**Subject: Beaver Valley Power Station, Unit Nos. 1 and 2
BV-1 Docket No. 50-334, License No. DPR-66
BV-2 Docket No. 50-412, License No. NPF-73
Supplemental Information for License Amendment Request
Nos. 320 (Unit No. 1 TAC No. MC6725) and
302/173 (Unit No. 1 TAC No. MC4645/Unit No. 2 TAC No. MC4646)**

Enclosure 2 of L-05-198

Pressurizer Safety Valve (PSV) Flow Capacity

Attachment A of Enclosure 2 of L-05-198
RSG Licensing Report - Revised Pages

Figure 5.3.15-1A
BVPS-1 Single Reactor Coolant Pump Locked Rotor
Reactor Vessel Flow and Faulted Loop Flow versus Time

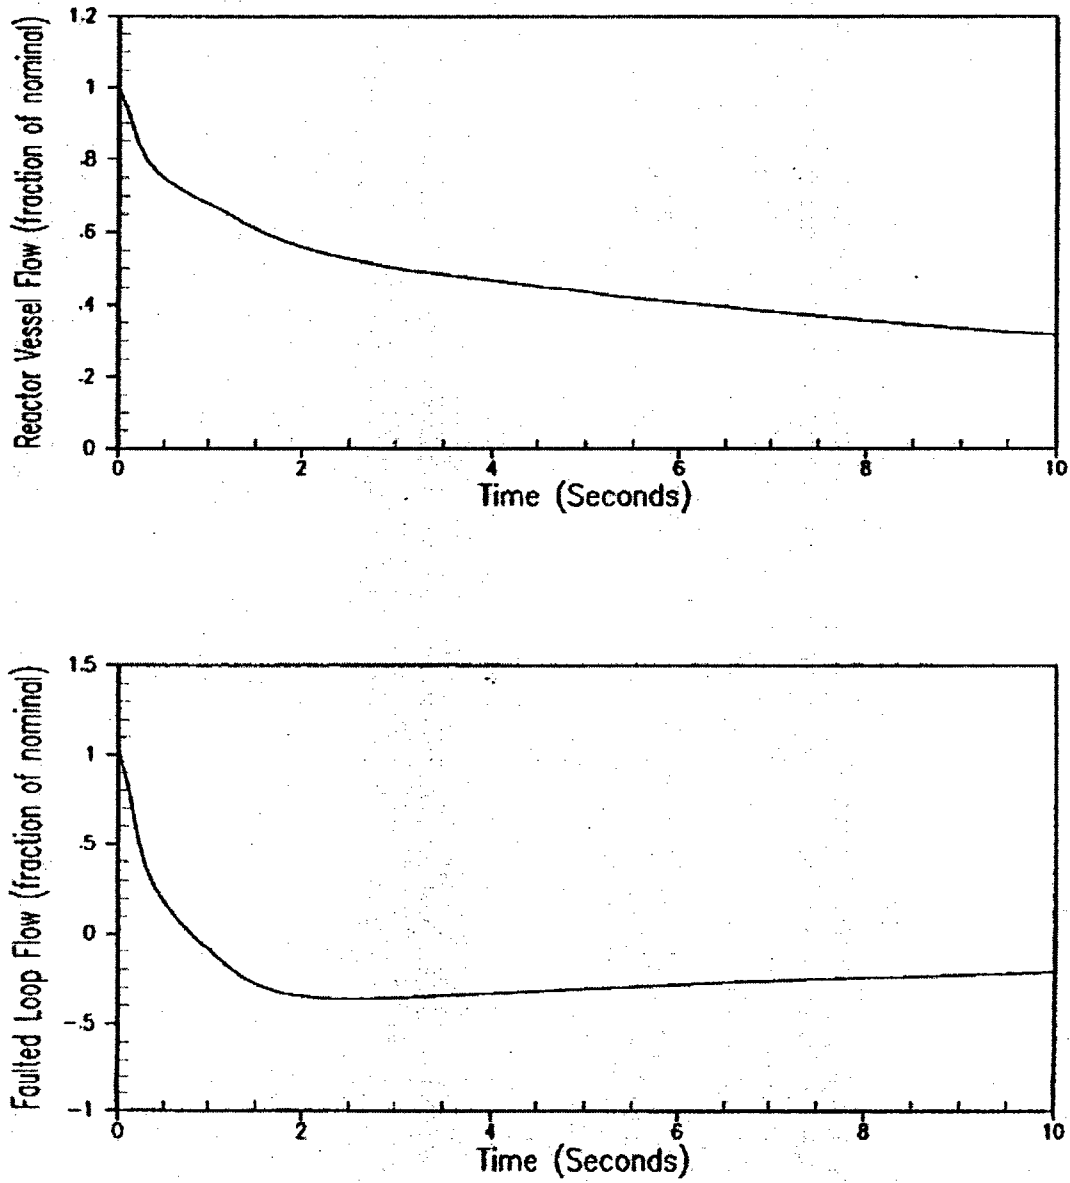
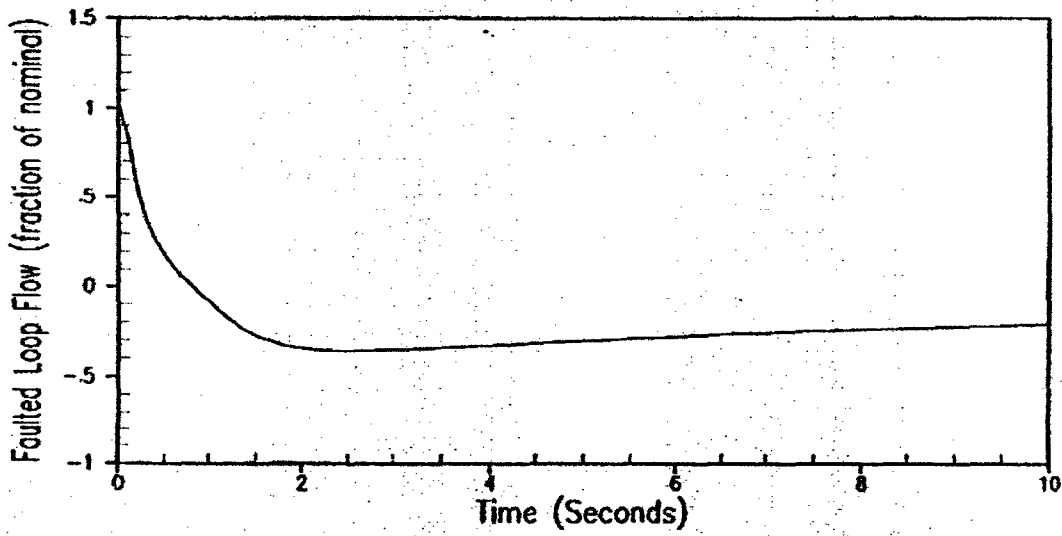
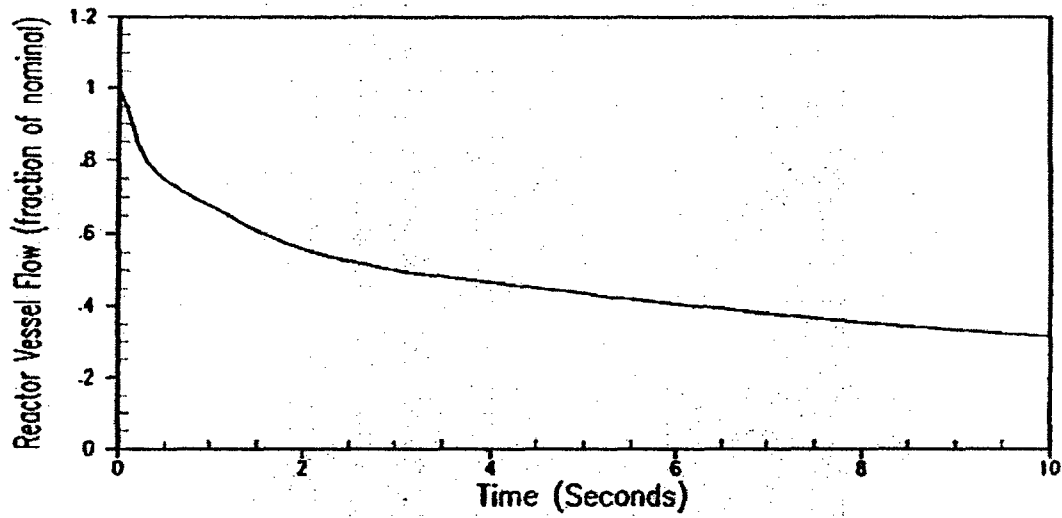
5-157	5-241	Replace existing Figure 5.3.15-1A with new figure
5-158	5-243	Replace existing Figure 5.3.15-2A with new figure
5-159	5-245	Replace existing Figure 5.3.15-3A with new figure
5-160	5-247	Replace existing Figure 5.3.15-4A with new figure
RSG & EPU Section 5.3.20, Summary		
5-185	5-307	Updated data presented in Table 5.3.20-1A
5-186	5-309	Updated data presented in Table 5.3.20-2A
EPU Section 9.1.3.6, RCS Design Calculations		
N/A	9-5	Updated statement to reflect that there are several limits used in RCS maximum pressure analyses
N/A	9-6	Updated statement to reflect the applicable safety analyses report sections that address reactor coolant and main steam system overpressure protection
